CITY PLANNING COMMISSION AGENDA

ITEM NOS: 5.A-5.E

STAFF: RICK O'CONNOR

PROJECT: THE RENAISSANCE AT INDIGO RANCH

DEV'T PLAN FIGURE 3

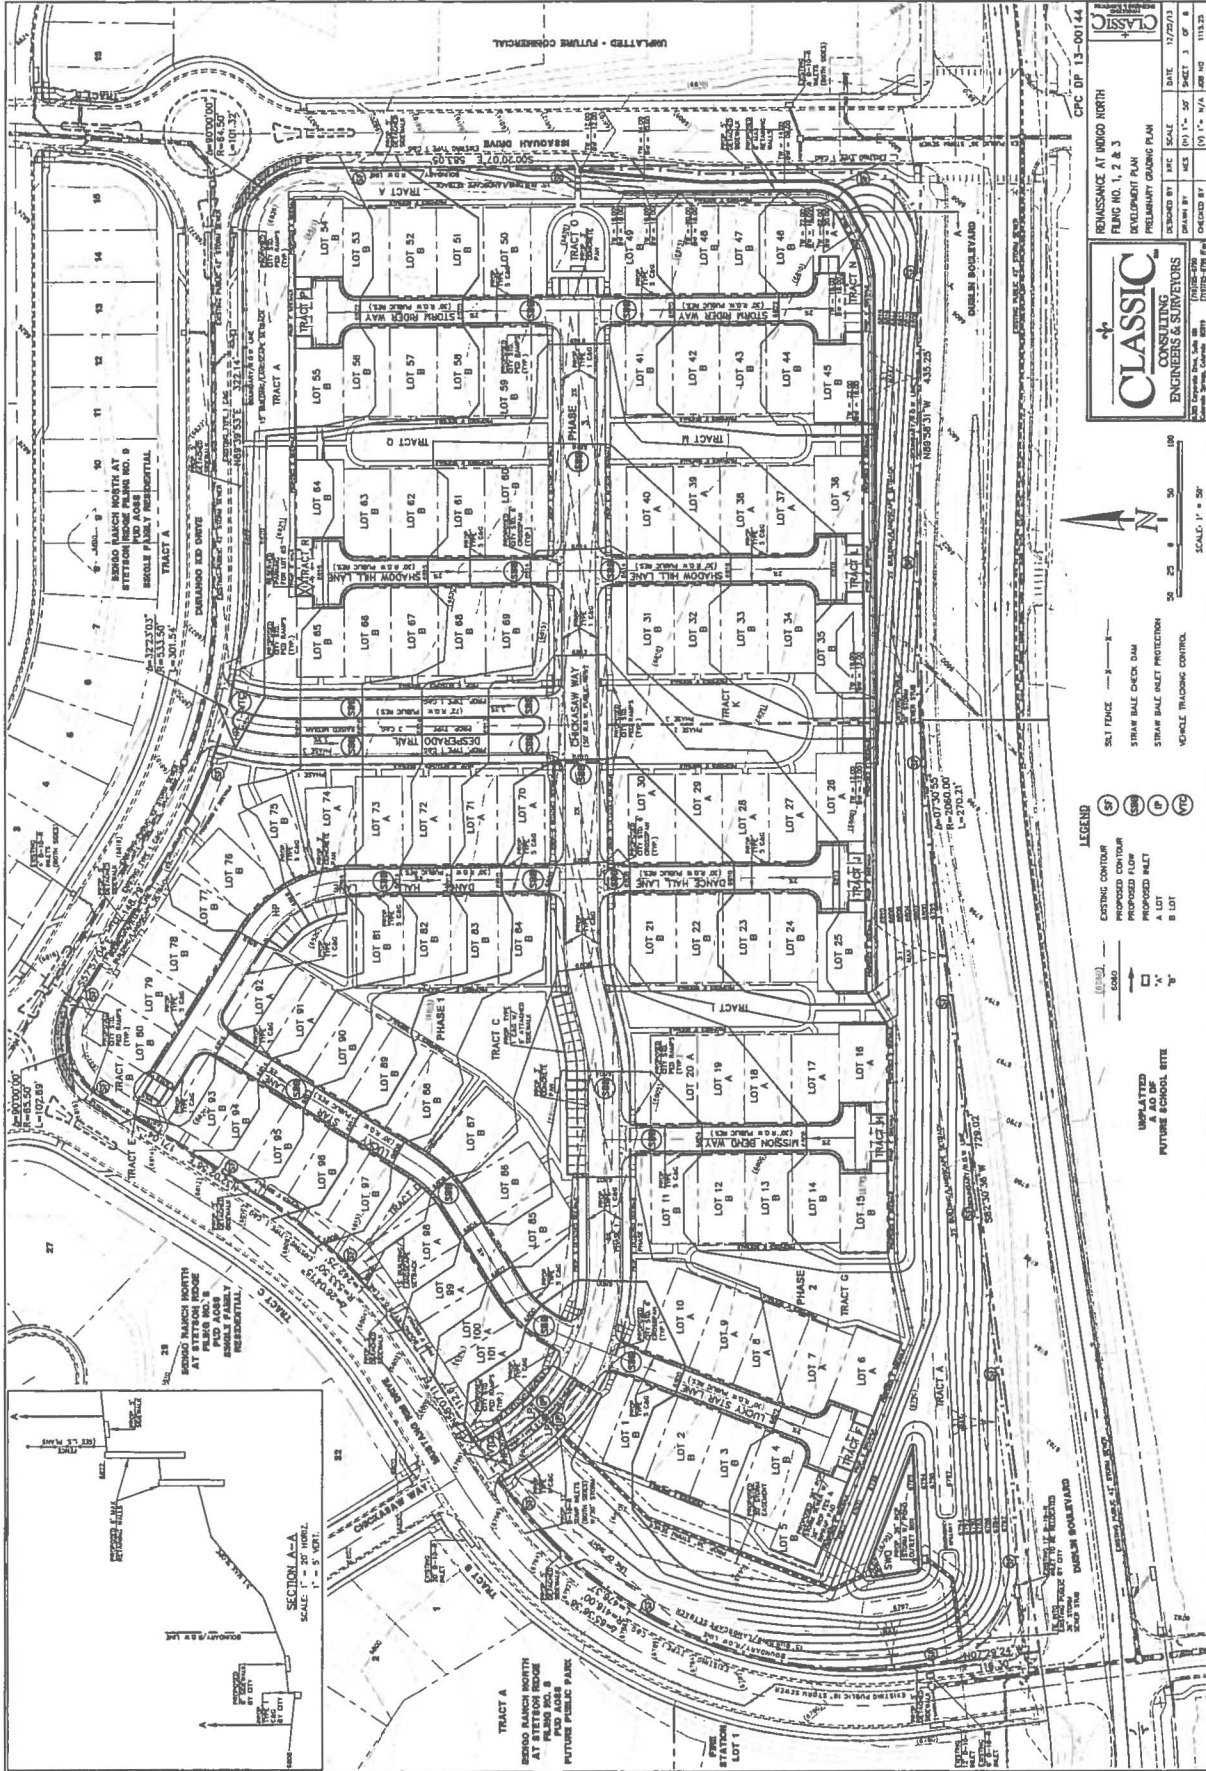
This application meets most of the review criteria and satisfies the intent of the small lot PUD concept. Two items that deviate from the criteria are road connections and the amount of units that are not Greenway Orientated units.

Within Chaparral Point, the internal rear access roadways are continuous and connect with a looped system. Within this proposal, many of the units are accessed with dead end streets (called "access" streets with a 22 foot mat/27 foot width to back of curb); however the number of units being served by the dead end streets is limited to not more than 10. The dead end streets do reduce the amount of pavement and provide adequate access to the units. City Engineering and Fire support this concept as public streets.

The second deviation is the number of units that do not actually front onto a greenway. The design manual limits the amount of non-greenway units to 10%; this proposal includes approximately 20% non-greenway units. While the non-greenway units do not have front loaded garages (all garages accessed in the rear), they do orient toward a street instead of a greenway. The minimum greenway width called out within the manual is a 40-foot width. Many of the units that do not face the greenway are along the two adjoining collector streets, Mustang Rim and Issaquah Drive.

Noise issues are one of the review criteria that deserve discussion. The typical standard to address noise is the construction of a noise wall and additional setbacks. While the setback area for this development is significant adjacent to Dublin, the applicants are not installing a noise wall and the grade actually rises from the road to the finished units. Instead, the applicants had a noise study completed to address this issue. Apparently the results indicate that additional soundproofing is necessary for those dwellings adjacent to Dublin. Staff has requested a copy of the study and a proposed technical modification below is suggested to update the development plan to address the necessary noise mitigation.

1. Sound study information from LSC was not provided. The development plan needs to include information as to specific units that are subject to additional sound attenuation. Provide a copy of the study and indicate on the development plan the affected units and the necessary noise mitigation.
 2. Provide a detail of the retaining walls (materials).
 3. Address the items noted by the Landscape Architect consisting of the following:
 - a. Include all street names and classifications on the landscape plan.
 - b. Show all Landscape categories requirements (setbacks, internal, and buffers if there are commercial uses across the non-arterial).
 4. Provide a letter from the Metro District which indicates that they will accept all responsibility for the ownership and maintenance of properties as noted on the plan.
-
